URBAN DESIGN COMMISSION APPLICATION

Title: 5555 Odana Road & 5534 Medical Circle

Odana Apartments, LLC c/o Bear Development, LLC ("Bear") is pleased to submit this application for Final Approval from the Urban Design Commission ("UDC") for our proposed project at 5555 Odana Road and 5534 Medical Circle. Please note that the plans have been updated to include addresses of 5559 Odana Road and 5542 Medical Circle to be consistent with the addresses assigned in the disposition letter for the Conditional Use Permit.

This submission follows the project's initial UDC approval, as well as the subsequent Conditional Use Permit, Demolition Permit and Certified Survey Map approvals granted by the Plan Commission and Common Council. The following responses address the design conditions issued in connection with the initial UDC approval, and the revised plans and materials included with this resubmission reflect each condition as described below. The balance of the items in the initial LOI and February 9th LOI are substantially similar and the scope of this LOI has been reduced to focus on the UDC conditions below and to provide additional clarification on staff comments received on April 21

2 PRIVACY FENCE
NOT TO SCALE

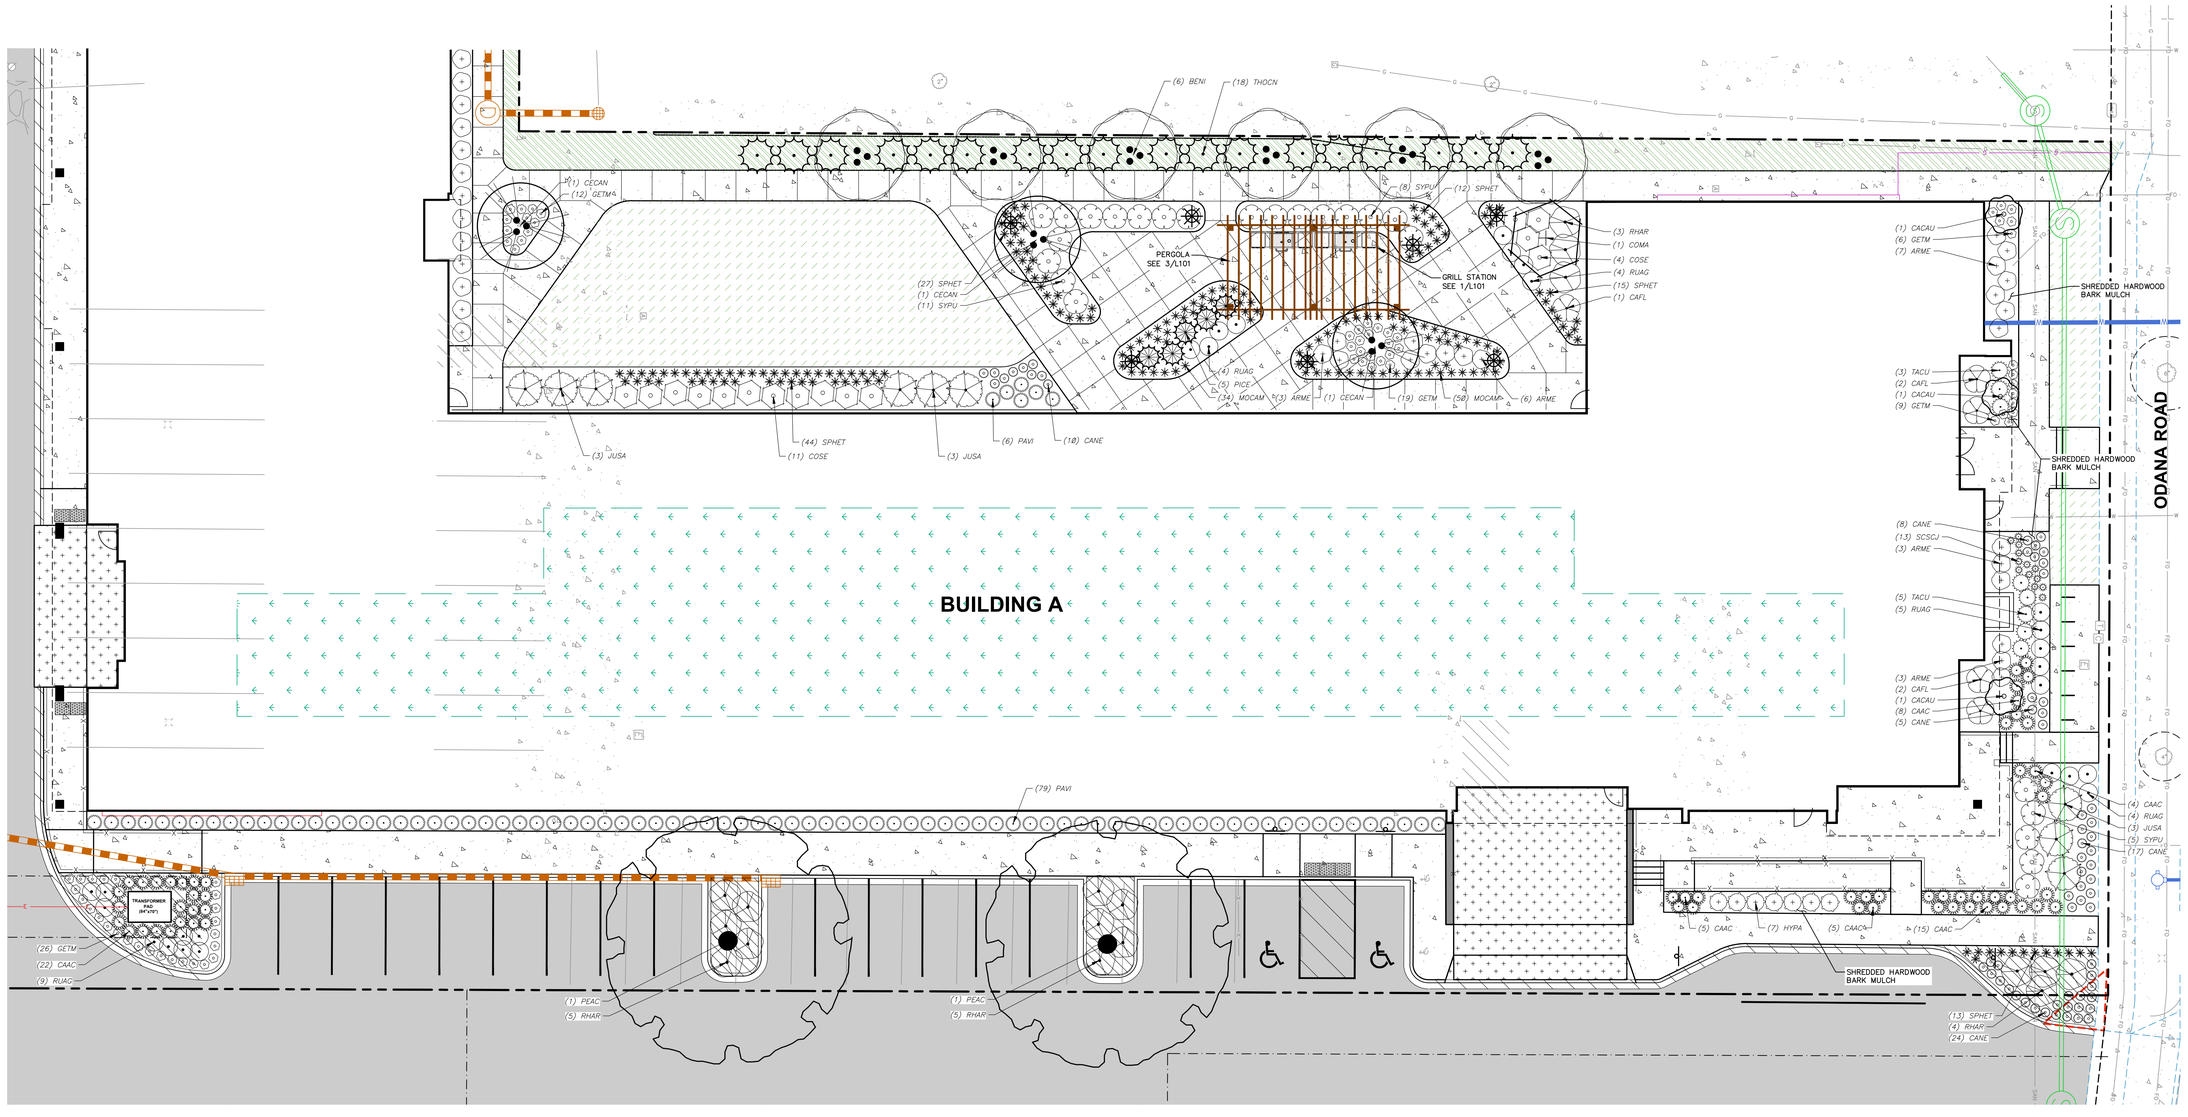
- **The fence material shall be revised to be a more organic material to be more contextually appropriate. The applicant shall provide a fence detail.**
    - The fence material has been revised from the previously proposed white vinyl material to Trex Seclusions composite fencing in Woodland Brown, as shown on sheet L101. This material provides a natural wood aesthetic contextually appropriate to the surrounding environment while offering long-term durability.

NOTES:
- FENCE TO BE TREX SECLUSIONS
- 6-FOOT HEIGHT
- WOODLAND BROWN COLOR

SHADOW DIAGRAMS

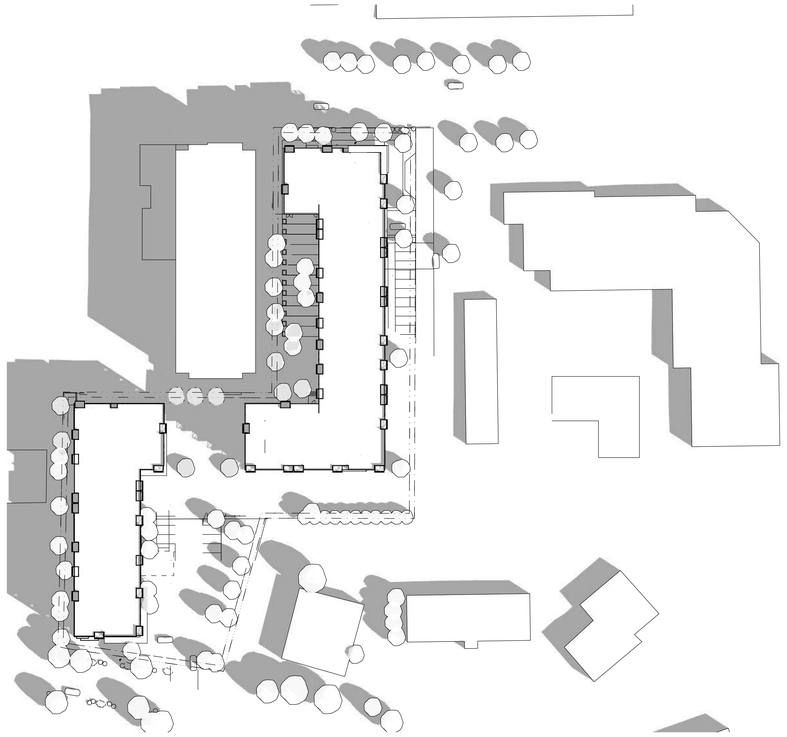
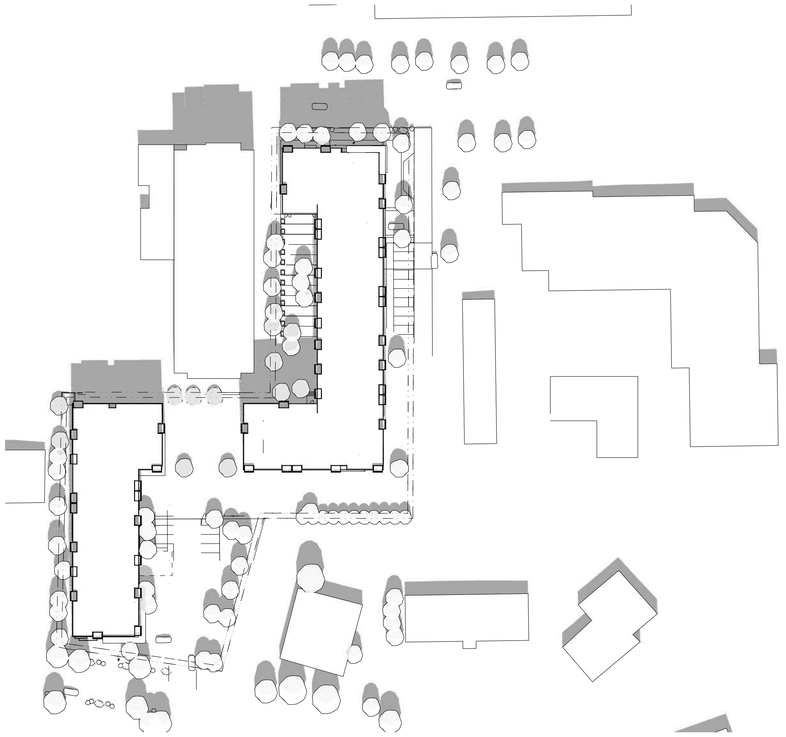
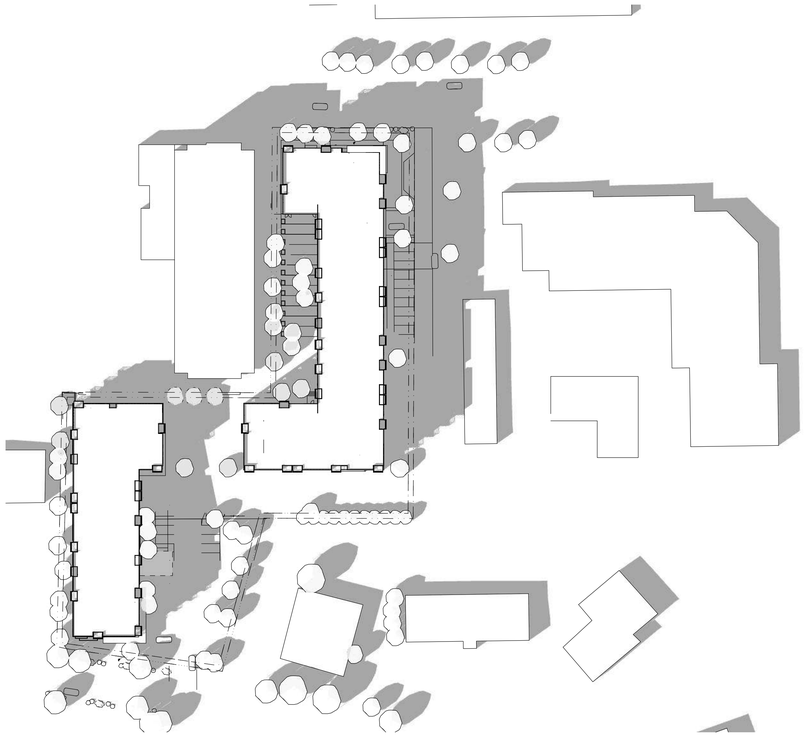
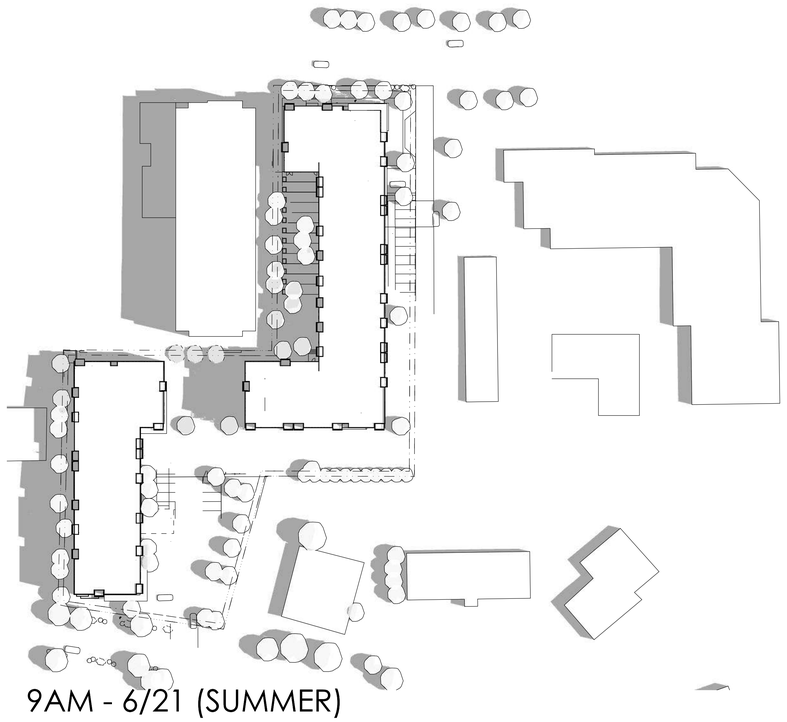
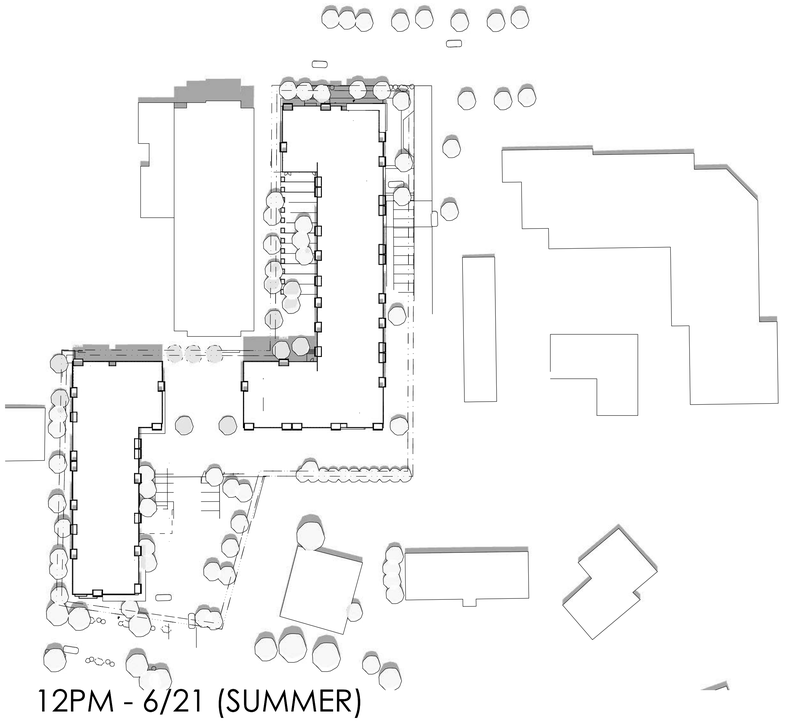
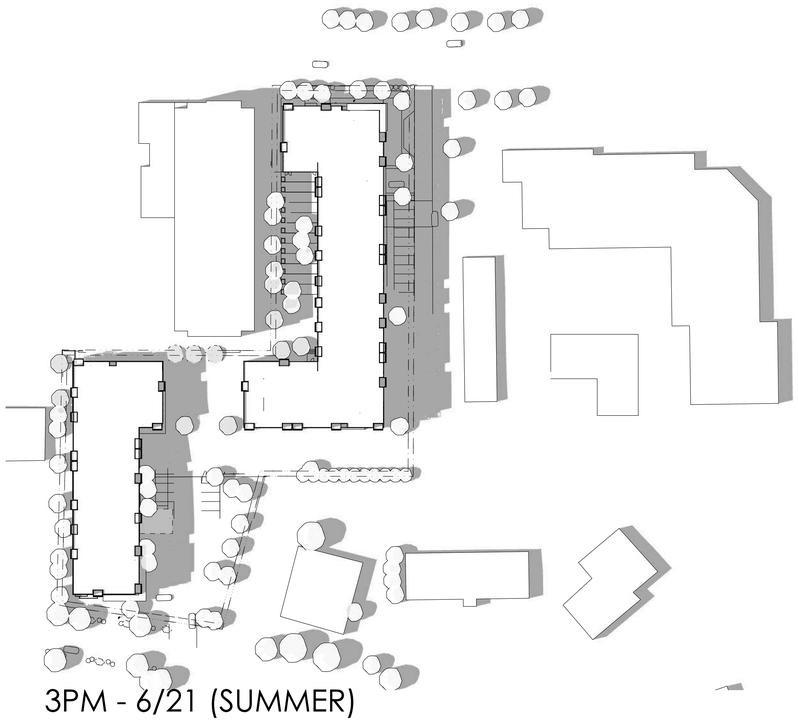
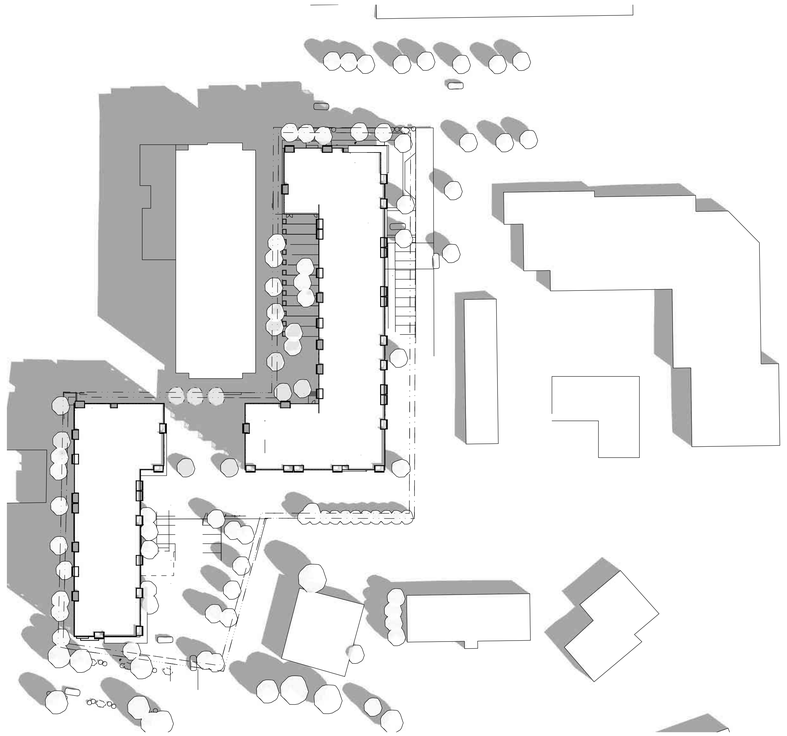
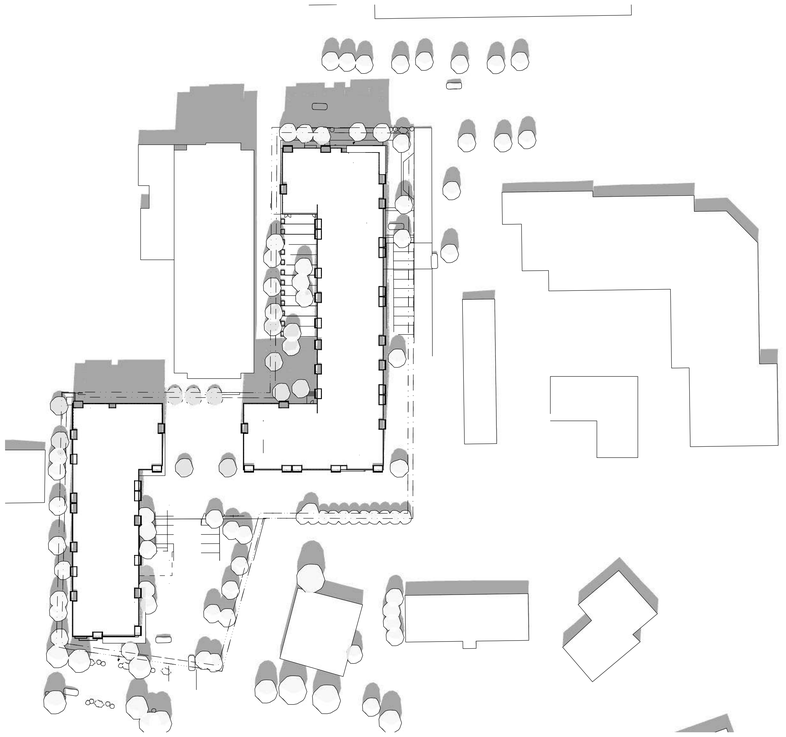
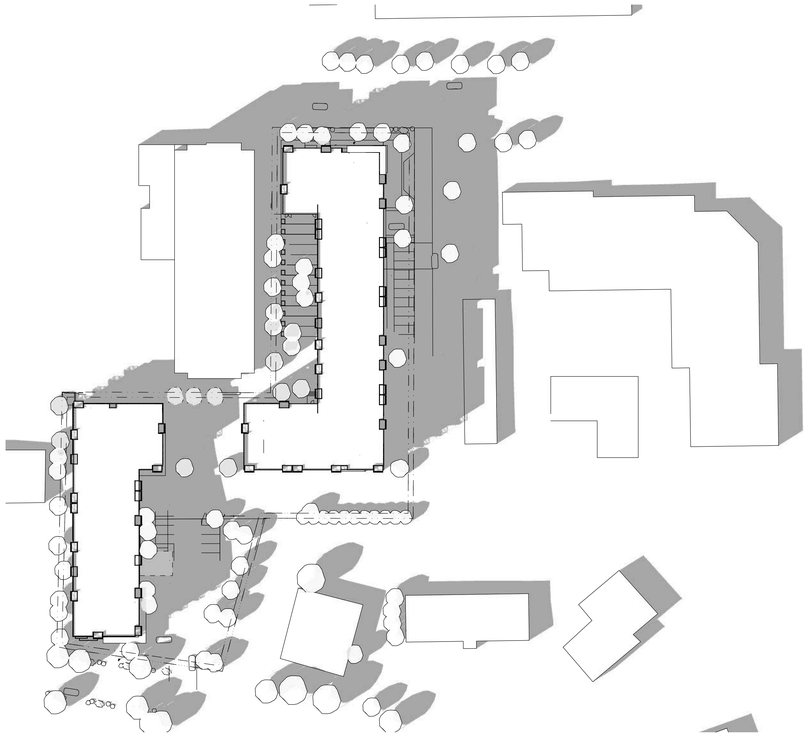
- **The Commission requested a site section and surrounding site contextual information to the landscape and site plans. If the applicant has conducted a shadow study, the Commission requested that it be provided.**
    - A site section along the shared property line with the neighboring school is shown on sheet L100. Surrounding context information is shown on the Locator Map and Contextual Site Plan exhibits. Shadow studies which demonstrate limited impact on neighboring properties have been included as well.
